Access Compliance Report

Public Rights-of-Way

Intersection ID: 14567	Main Street: E_TREMONT_AV	Cross Street: LYNDHURST_AV	Location: W
ADA ID: 7DD98F544F21	Ramp Type: Directional1	Initial Pass/Fail: Fail	Overall Compliance: No
			Severity Score: 21.25

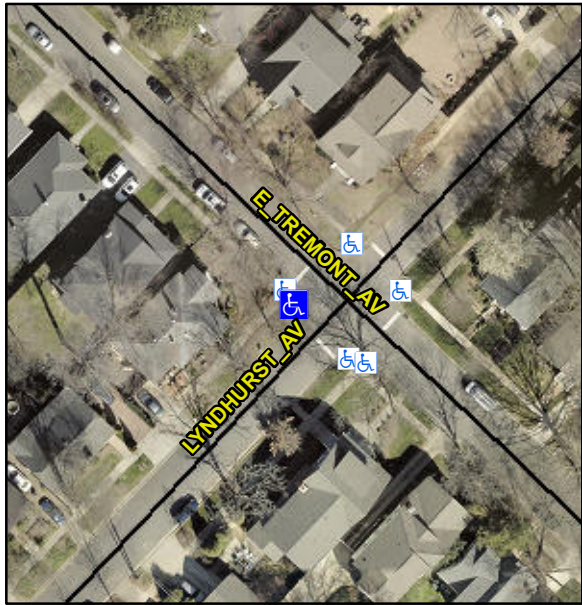
Codes/Mitigation Info/Possible Solution			Field Measurements/Component Compliance					
	Possible Solutions:		Compliance	Description	Data	Compliance	Description	Data
	Remove & Replace Entire Ramp.		N/A	Ramp Length (in)	60.0	N/A	Grade Break?	N/A
			No	Ramp Width (in)	46.0	N/A	Grade Break Slope (%)	0.0
			No	Ramp Slope (%)	9.6	N/A	Grade Break XSlope (%)	0.0
			Yes	Ramp XSlope (%)	1.8			
			N/A	Flare Type LT	N/A	N/A	Flare Type RT	N/A
			N/A	Flare Slope LT (%)	N/A	N/A	Flare Slope RT (%)	0.0
			N/A	Flare Traversable LT?	N/A	N/A	Flare Traversable RT?	N/A
	Surveyor Notes:		N/A	Landing Length (in)	0.0	N/A	DWS Provided?	N/A
			N/A	Landing Width (in)	0.0	N/A	DWS Contrast?	N/A
		N/A	Landing Slope (%)	0.0	N/A	DWS Length (in)	N/A	
		N/A	Landing X Slope (%)	0.0	N/A	DWS Full Width?	N/A	
PROW/ADA:		N/A	Landing Curb? (Y/N)	N/A	N/A	DWS Offset LT (in)	N/A	
R304.5.1, R304.2.2		N/A	Shared Landing?	N/A	N/A	DWS Offset RT (in)	N/A

N/A	Gutter Ponding?	0.0	N/A	Gutter Slope (%)	N/A	
		N/A	Gutter Lip Ht (in)	1.0	N/A	Gutter X Slope (%)	N/A	
		N/A	Painted X Walk1?	No		Road Slope (%)	0.0	
			X Walk 1 Direction	To SE		Road X Slope (%)	1.2	
			X Walk 1 Width (in)	N/A		Clear Space?	N/A	
			X Walk 1 Slope (%)	0.0	N/A	Clear Space to XWalk (in)	N/A	
			X Walk 1 X Slope (%)	1.2	N/A	Storm Grate/Utility Hazard?	N/A	
		N/A	Ramp inside XWalk1?	N/A		Storm Grate/Utility Type		
		N/A	Any Obstructions?	N/A			N/A	
			Obstruction Type		Yes	Surface Condition? (G/P)	Good	
					N/A	Curb Slope (%)	0.9	
Street 1 Name		LYNDHURST AV						
Stop Condition-Street 1		StopSign						
Street 2 Name		N/A						
Stop Condition-Street 2		N/A						
Total Cost:		\$ 1600.00
